**NW Natural Pre-Remedial Design Data Gaps Sampling  
Gasco Sediments Site – Spring 2020  
Field Change Request Form**

**Project Name:** Gasco Sediments Cleanup Action      **Subconsultant:** Anchor QEA, LLC

**Field Activity:** Subsurface Sediment Sampling      **Request Number:** 15

**Field Change Request (FCR) Title:** Additional Perimeter Subsurface Sediment Core Collection and Analyses to Determine Final Project Area

**Figure 1**  
**Proposed Additional Subsurface Sediment Core Locations**  
 Field Change Request No. 15  
 Gasco Sediments Cleanup Action

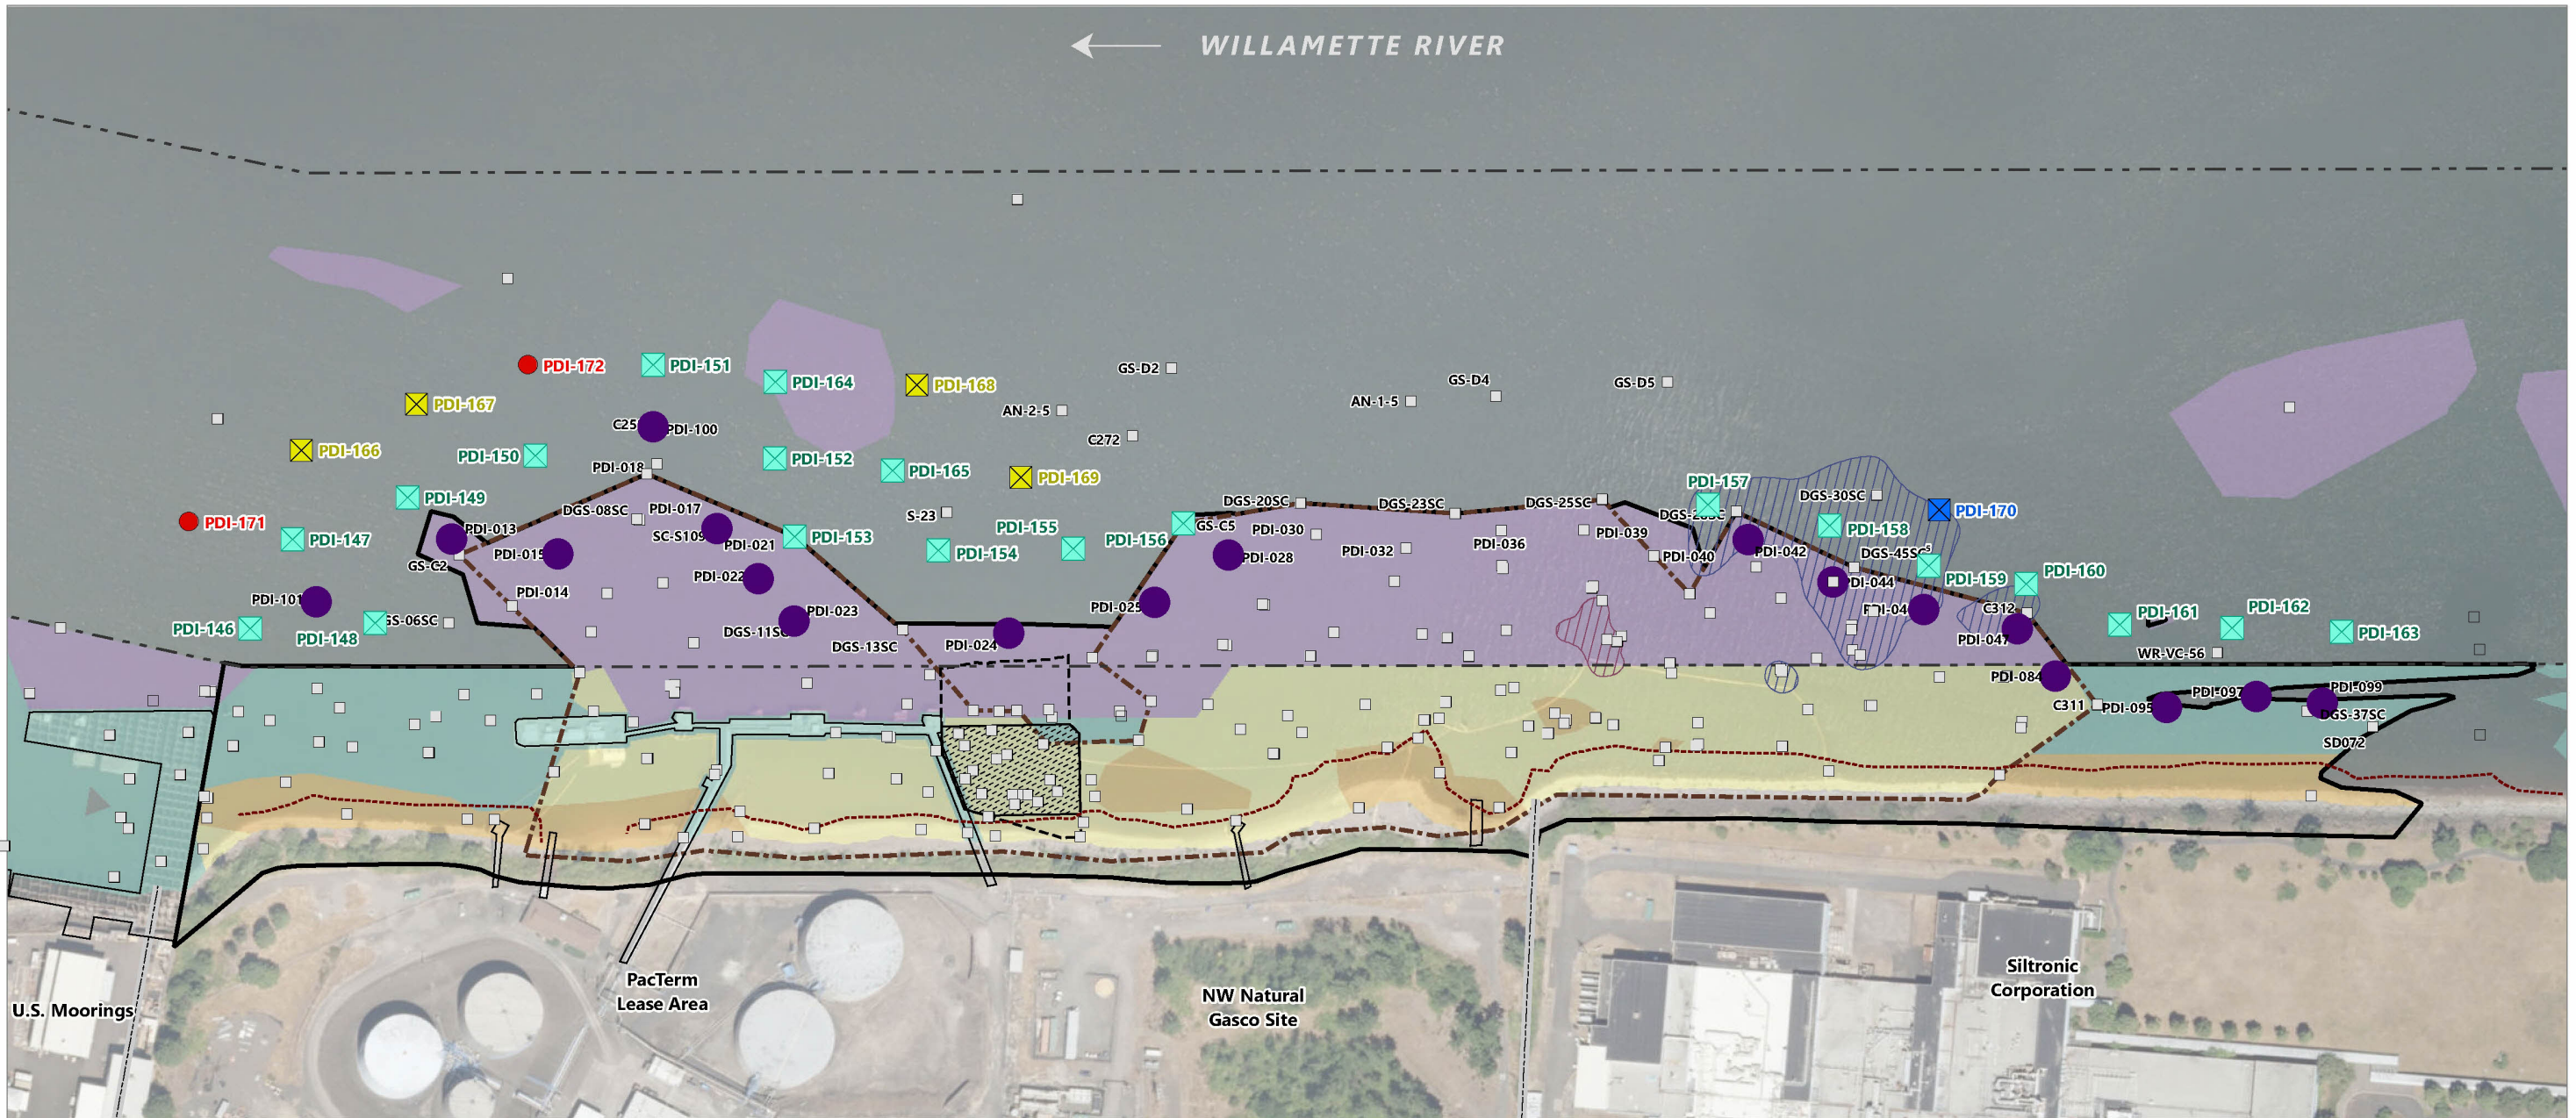
Recommended Change
<p>NW Natural proposes to collect two additional sediment cores less than 150 feet from locations PDI-146, PDI-147, PDI-149, and PDI-150 at the stations shown in Figure 1 with the geographic coordinates provided in Table 1. In addition, two of the four locations (PDI-166 and PDI-167) in the EPA-approved FCR 13 (dated May 8, 2020) that have not yet been collected will be slightly adjusted to maintain the data density required for remedial design as shown in Figure 1 with the geographic coordinates provided in Table 1. The samples will be collected, processed, and submitted for chemical analysis consistent with FCR 10.</p>
